# Submissions Report

Rail infrastructure, stations, precincts and operations

Figure 2-2 Revised indicative layout and key design elements – Westmead metro station

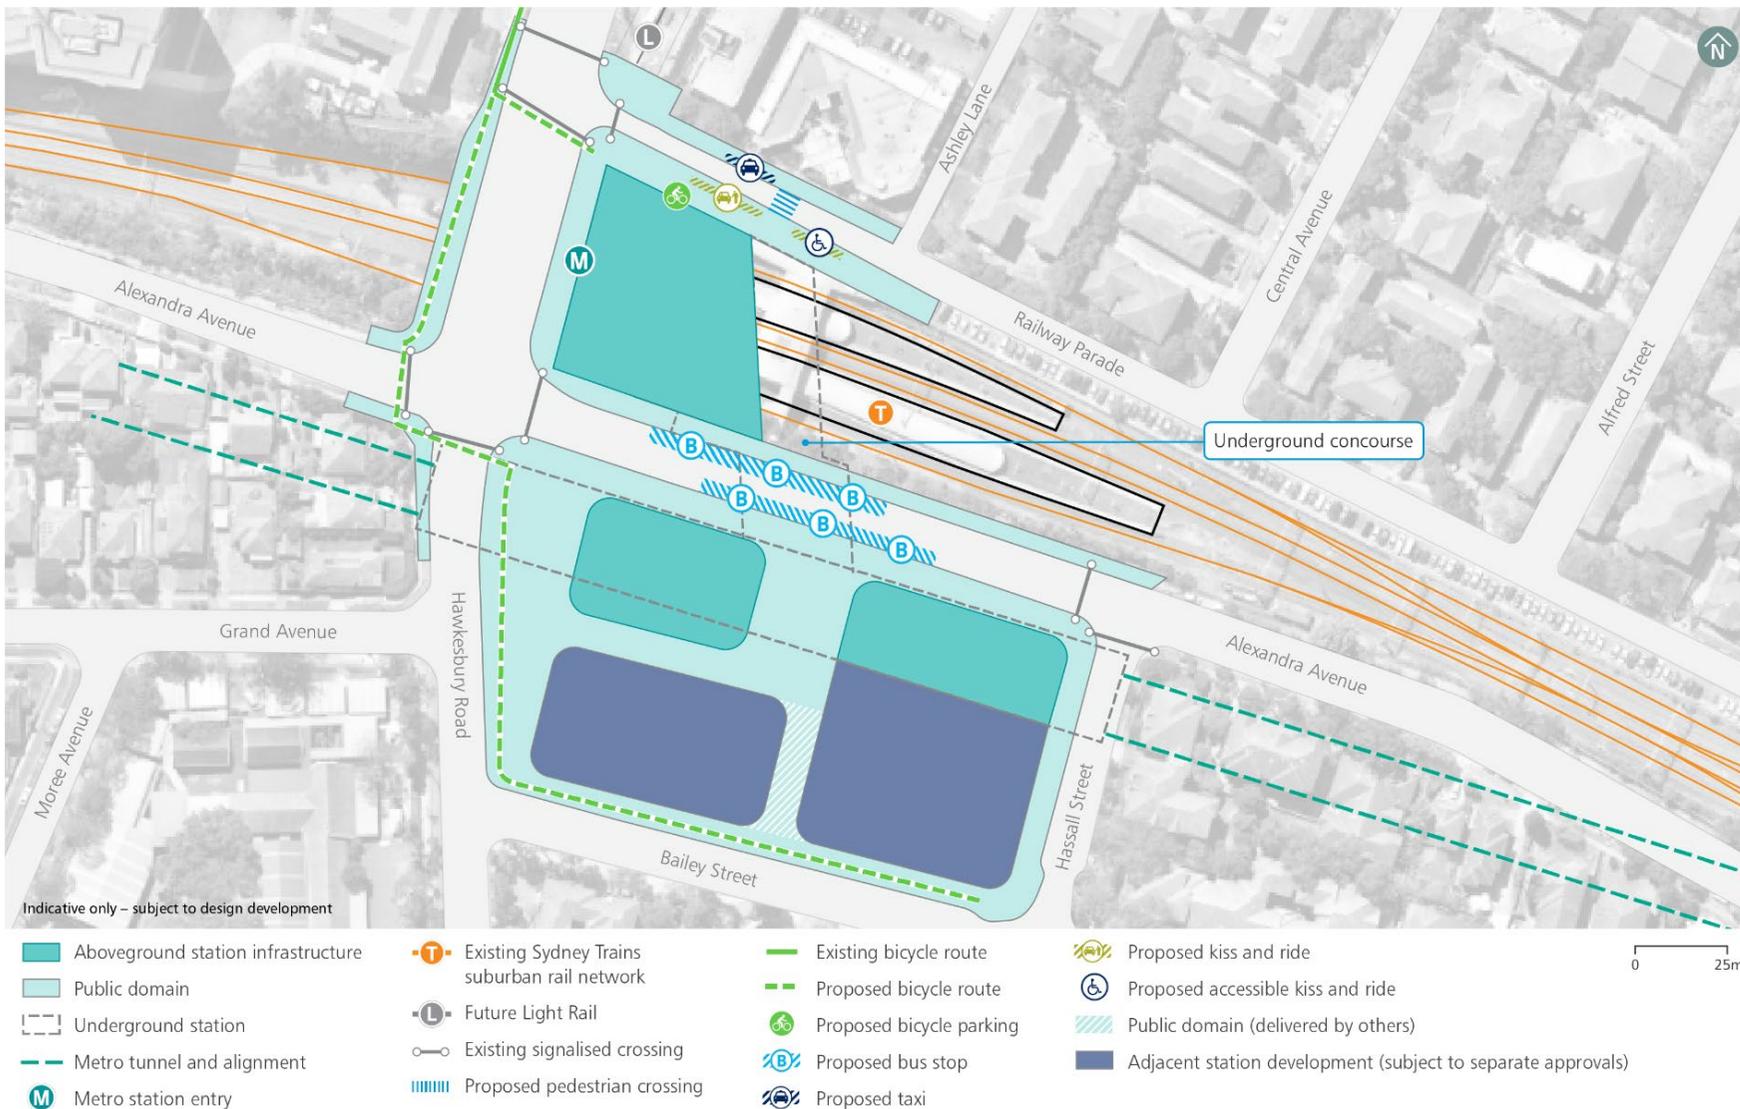
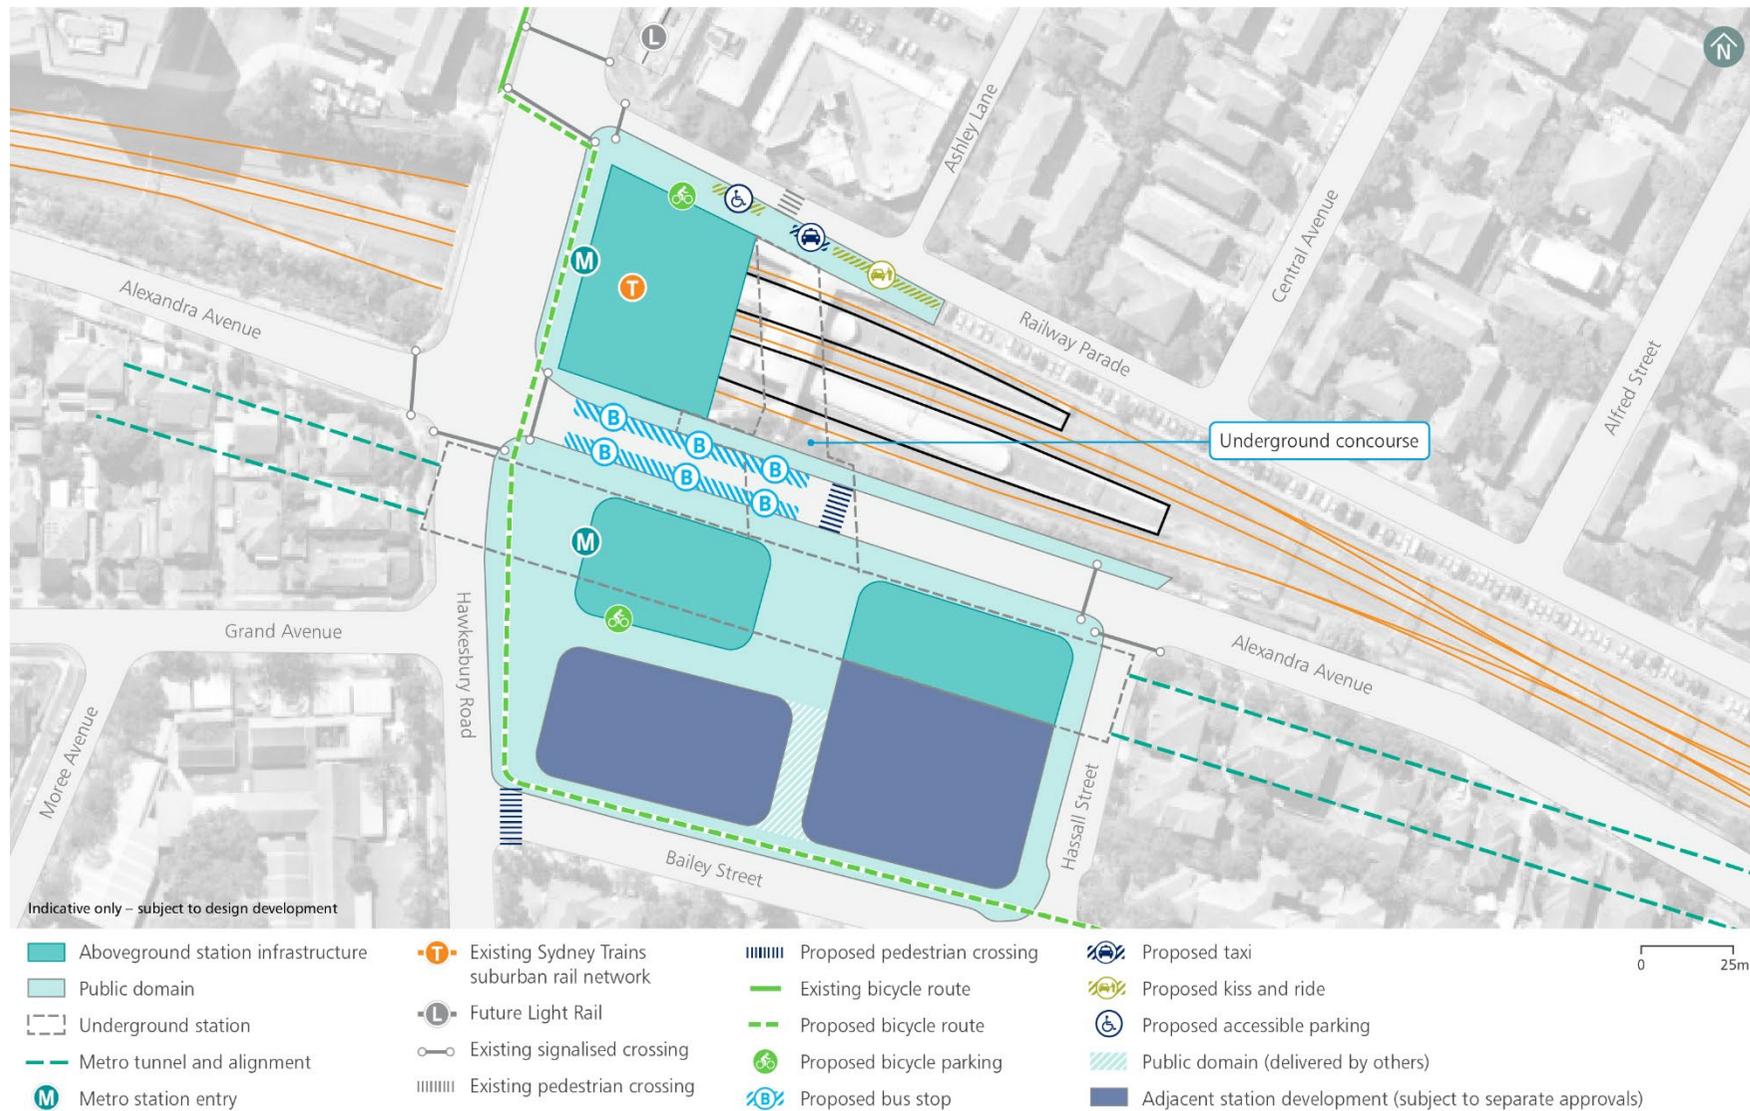
The exhibited layout and key design elements for Westmead metro station are shown in Figure 2-1. The revised layout and key design elements are shown in Figure 2-2.

In addition, Figure 7-1 of the Environmental Impact Statement identified a 'proposed pedestrian crossing' on Railway Parade (reproduced as Figure 2-1). Figure 2-2 has been corrected to clarify that this is an existing pedestrian crossing that would be retained.

**Figure 2-7 Revised potential change in flood levels (one per cent AEP event with climate change) - Westmead metro station**

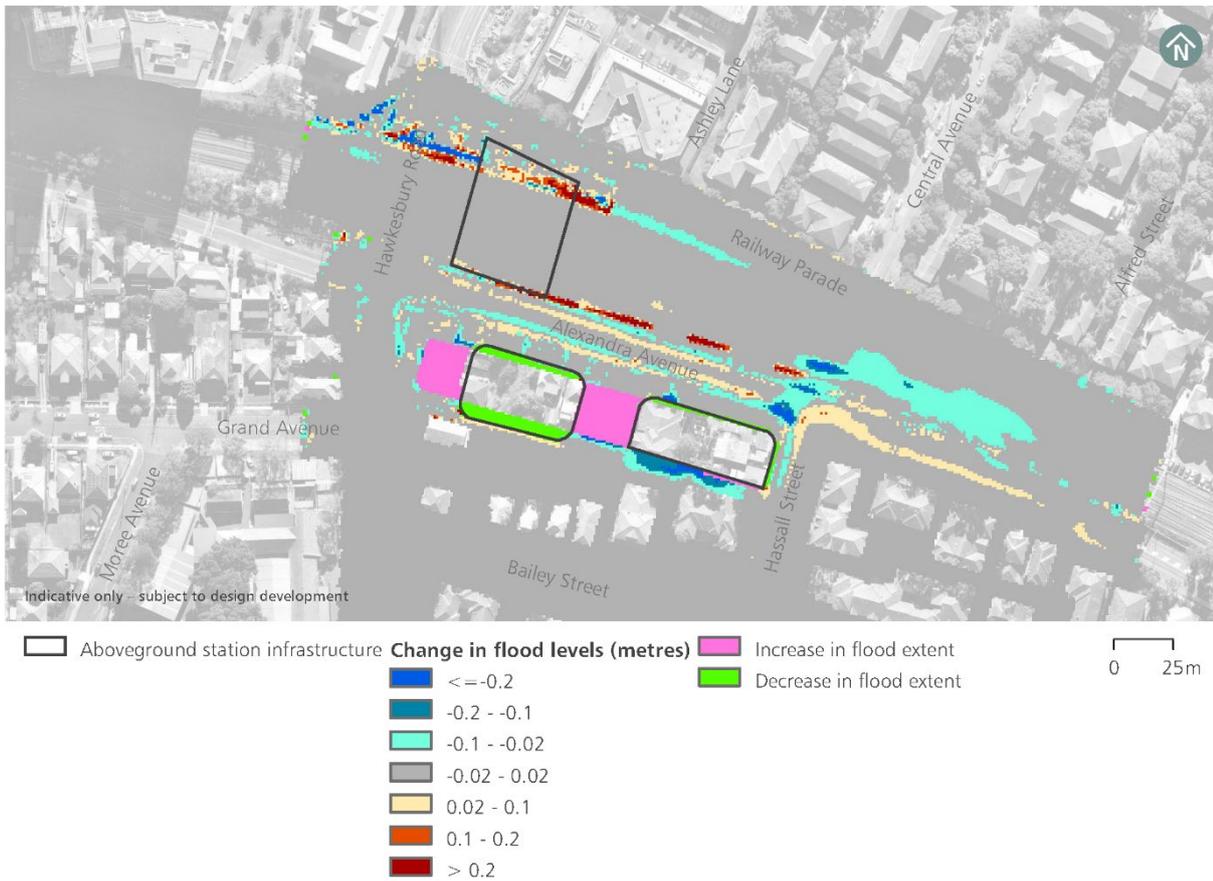
Assessment of potential flooding impacts at Westmead metro station from the design refinements and a comparison to the Environmental Impact Statement assessment is provided in Table 2-2. Figure 2-7 shows the revised potential change in flood levels (including the proposed design refinements) for the one per cent AEP (with climate change). Appendix H (Flooding technical information) includes the updated flood mapping at Westmead metro station as a result of the proposed refinements for a range of flood events.

**Figure 2-9 Revised indicative layout and key design elements – Parramatta metro station**

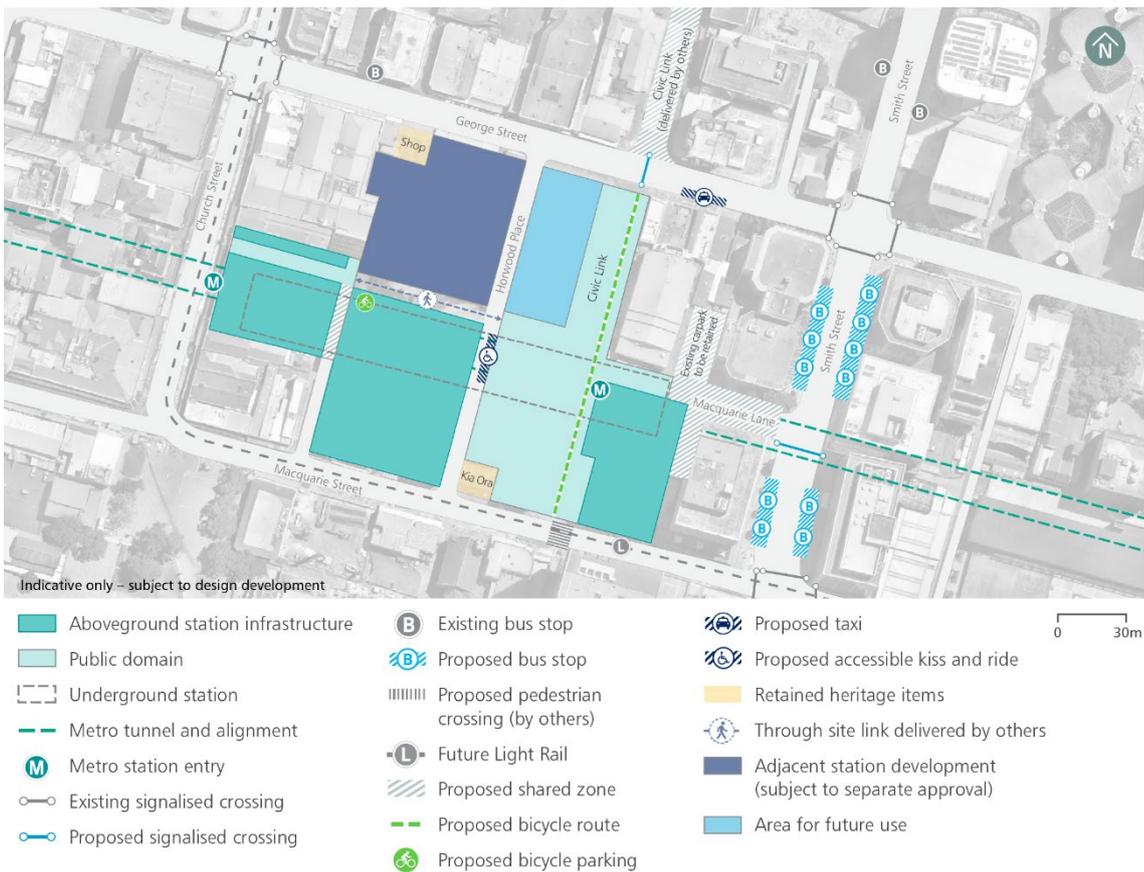
The refinements at Parramatta metro station include a reduction in the area required for the excavation of the underground station box. Part of the station services which were proposed to be underground within the excavated station box would instead be located aboveground within additional station infrastructure as part of this proposal. This aboveground station services infrastructure would be located to the west of Horwood Place within the building previously proposed as over station development in the exhibited design (refer to Figure 2-8).

The exhibited figures showing the indicative layout and key design elements, indicative long-section, indicative cross-section and potential over station development extent in the Environmental Impact Statement are shown in Figure 2-8, Figure 2-10, Figure 2-12 and Figure 2-14, respectively. The refinements are shown in Figure 2-9, Figure 2-11, Figure 2-13 and Figure 2-15.

**Figure 2-15 Revised potential over station development extent – Parramatta metro station**

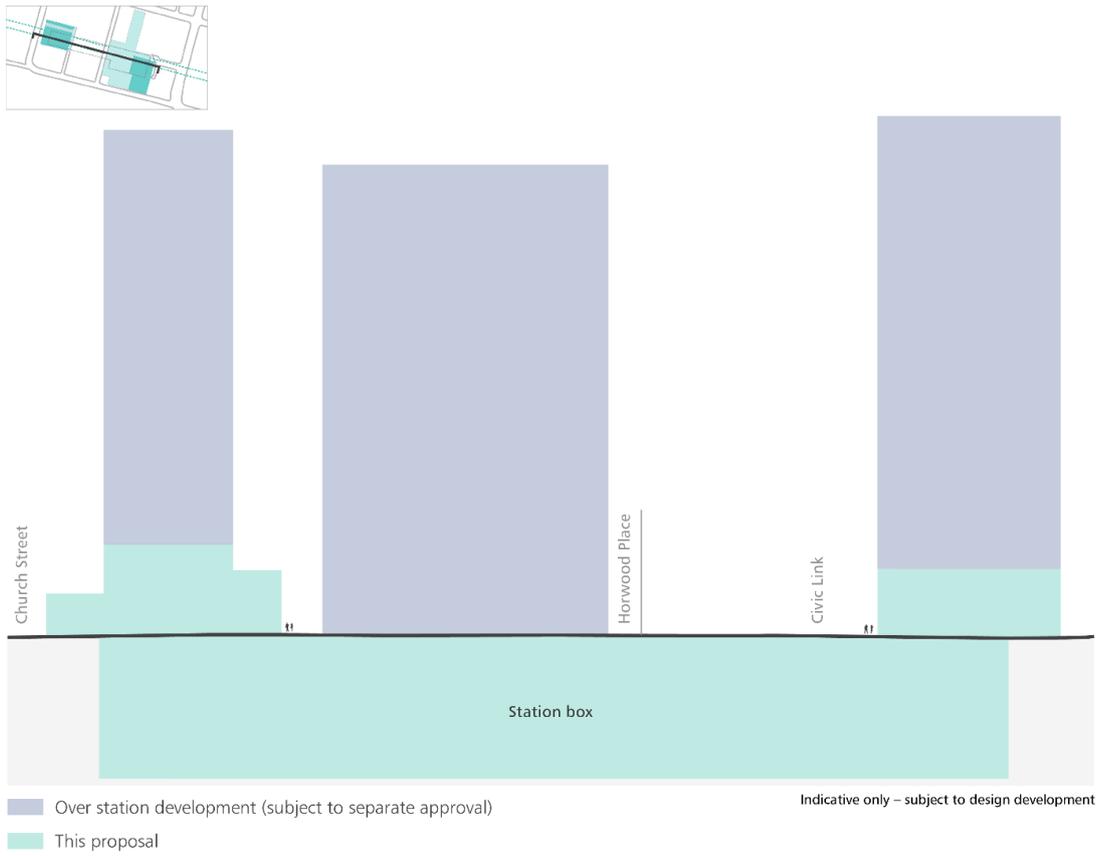
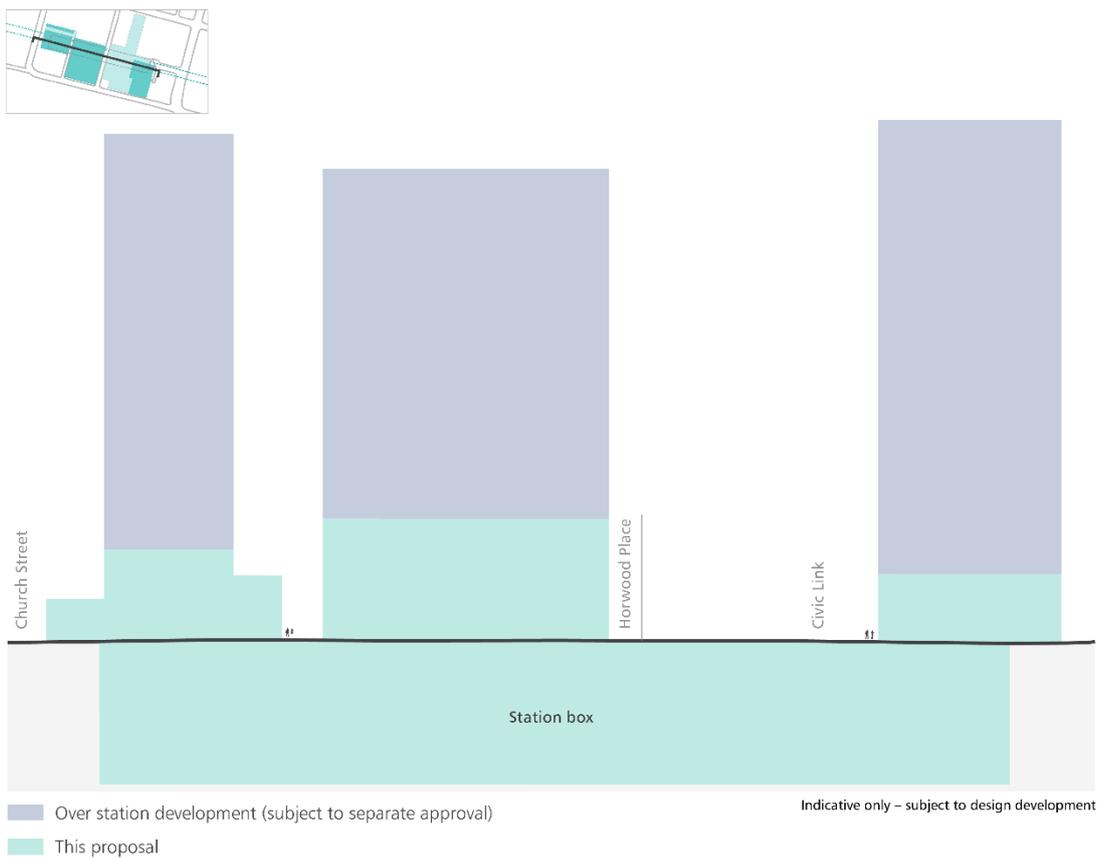
As a result, the extent of the future over station development at this location would be situated above the station services infrastructure (subject to separate approval, as outlined in Section 2.6 of the Environmental Impact Statement). The additional aboveground station services infrastructure would be, subject to design development, about 21 metres above street level (refer to Figure 2-11). The future over station development would be subject to a separate planning approvals process, including community and stakeholder engagement.

**Figure 2-17 Revised indicative construction site layout - Parramatta metro station**

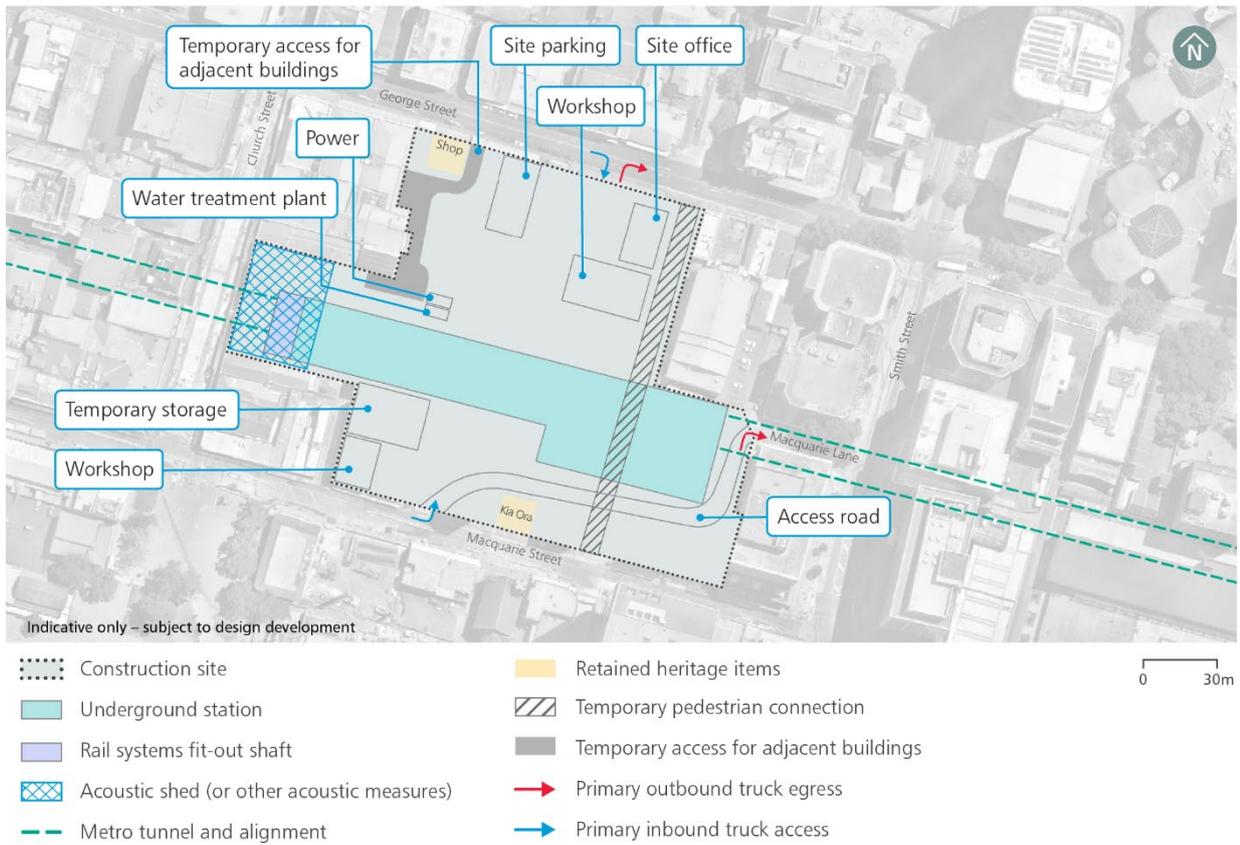
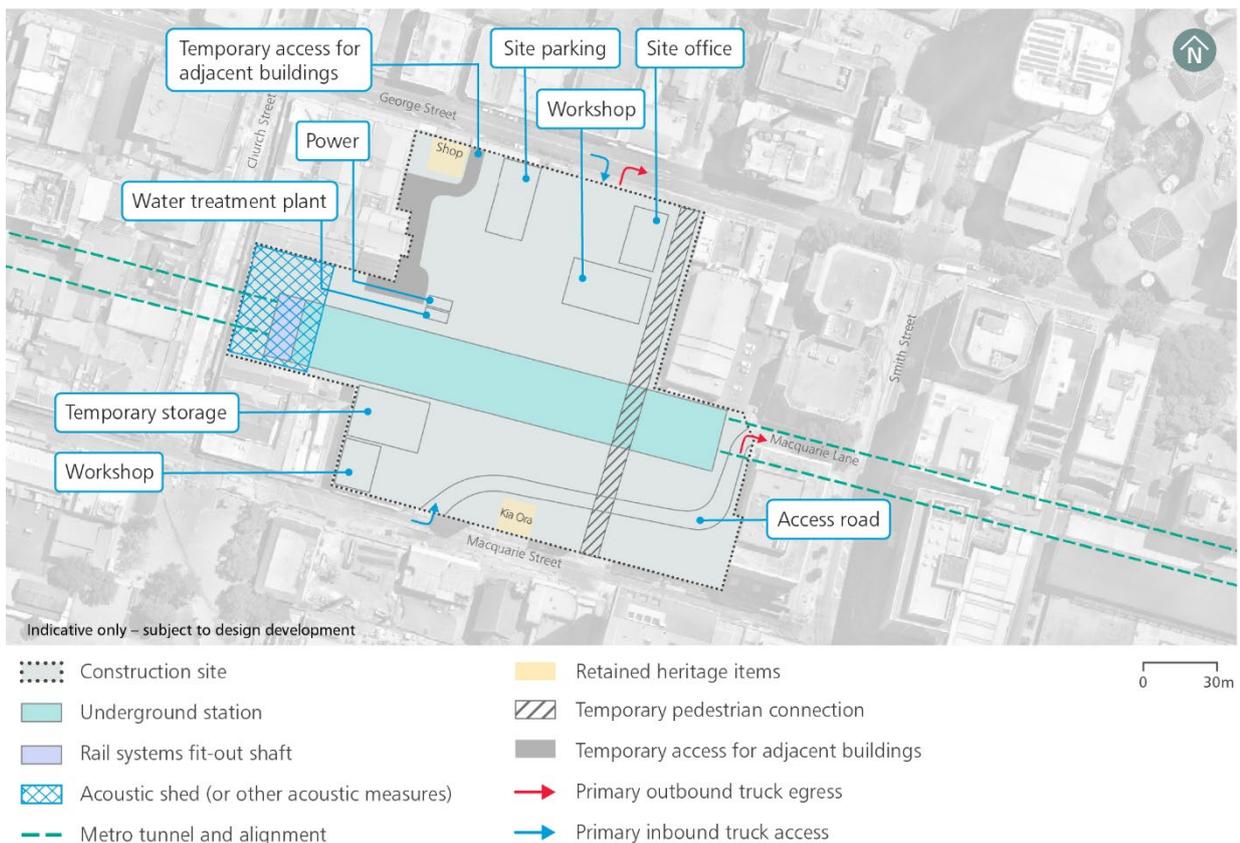
Construction of this proposal would also now include construction of the additional aboveground station services infrastructure to the west of Horwood Place. This building would be constructed using the methodology described in the Environmental Impact Statement for similar structures. This building was previously proposed to be wholly delivered as part of the future over station development (subject to separate approval). This aboveground station services infrastructure now included in this proposal would include provisions (such as structural elements) to enable the construction of the future over station development (subject to separate approval).

The exhibited indicative construction site layout is shown in Figure 2-16 and the exhibited extent of basement structures is shown in Figure 2-18. The revised construction site layout and extent of basement structures are shown in Figure 2-17 and Figure 2-19.
